Memo

To: Josh Mihaly
From: Jeff Walton, Associate Planner; 910-341-3260
CC: File;
Date: 5/13/2016
Re: Sea Sell Auto

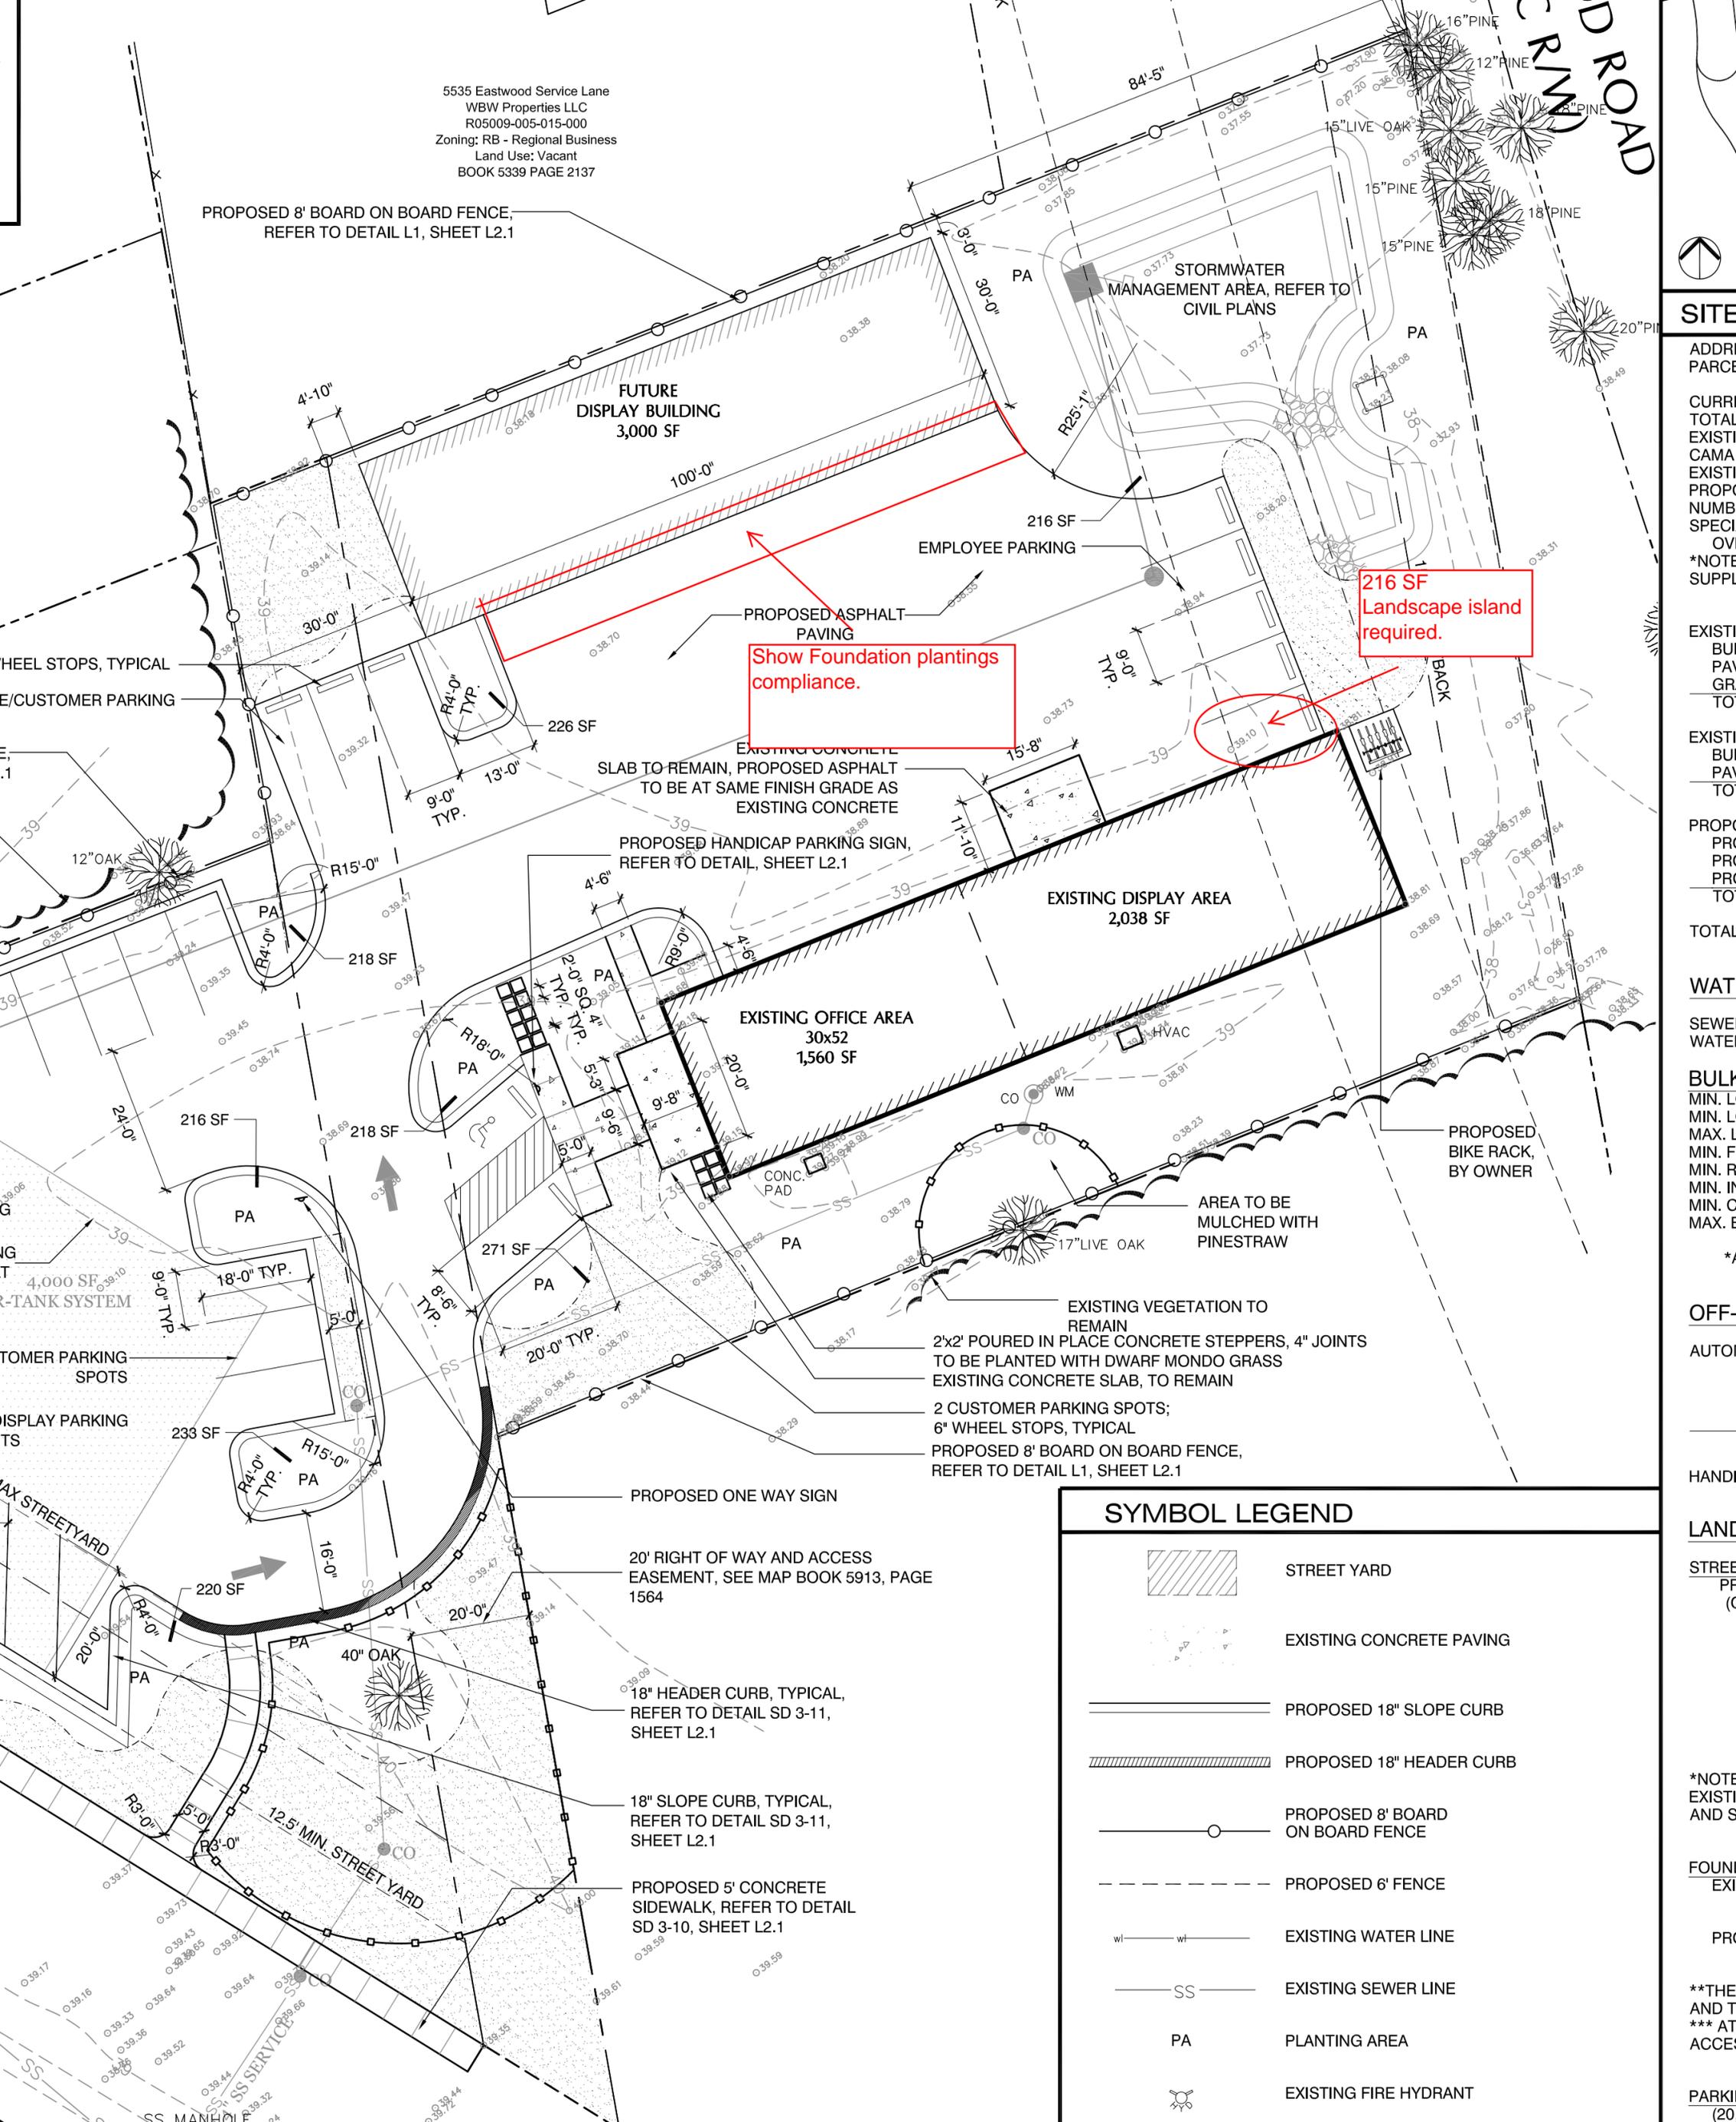
- In the attached redline, you are missing a landscape island. I know we have talked about this island already.
 - I don't have the authority to approve this plan set missing the island. My only offer to apply for a variance from this requirement to the Board of Adjustment.

- Show compliance with foundation plantings for both buildings.
 - I keep commenting on this and quoted code on the previous comments. I don't have a way of exempting the foundation plantings for either building. I need you to show compliance for the foundation in front of the future building.
 - I don't have the authority to approve this plan set missing the foundation area in front of the future building. My only offer to apply for a variance from this requirement to the Board of Adjustment.

216 SF
 Landscape island
 required.

Show Foundation plantings
 compliance.
